BID NO. 20-37

SUBJECT: Improvements to the Arlington Town Hall Plaza

ADDENDUM NO. 2

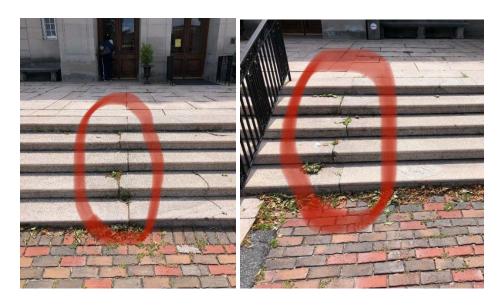
1. Question: What are the specific brick pavers (manufacturer and type) to be matched?

Response: Contractor shall note the existing brick manufacturer and type to be matched are unknown, but on-site observations seem to indicate that the

existing bricks are Stiles and Hart, City Hall Pavers. Contractor shall match the existing pavers in size and color per the specifications, but all new brick pavers shall be wire cut and installed per the contract drawings.
